DSOX2012A-03

S E R V I C E N O T E

DSOX2012A – Oscilloscope, Mixed Signal, 2 Channel,
100MHz

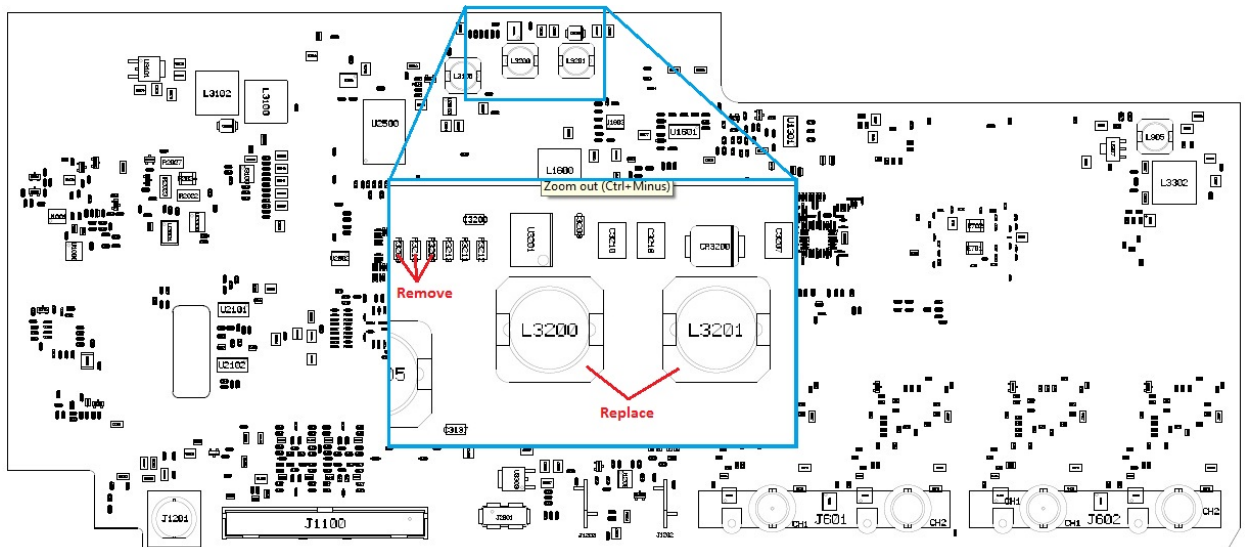
With the oscilloscope power turned on and while under normal operation, the unit emits a hissing noise.

2. As the picture indicates, remove the three resistors (0699-7209, 1 Ohm) located at R3208, R3209, and R3210. They are not to be replaced.
3. Remove as well the two inductors (9140-6474, 100uH) located at L3200 and L3201 and replace them with inductors with part number 9140-6151 (68 uH).
4. Re-assemble to the point where the unit could be powered up to verify that the hissing is indeed gone. If the hissing is not gone, please, check modifications.
5. When the hissing is gone, put oscilloscope back together.
